Product Change Notice (PCN)

PCN Number: **PCN-0370535R-01**

Product(s) Affected: **CMT-0525-75-SMT-TR**

Previous Orientation	Current Orientation

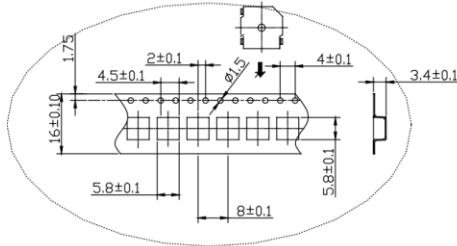
Reason(s) for Change: **Upgraded reel machine.**

Description of Change: **Buzzer shifted 90 degrees in the tape. See drawing below for tape update.**

Affected Date Code: **2612**

Product Availability: **All goods produced on or after the date code 2612**
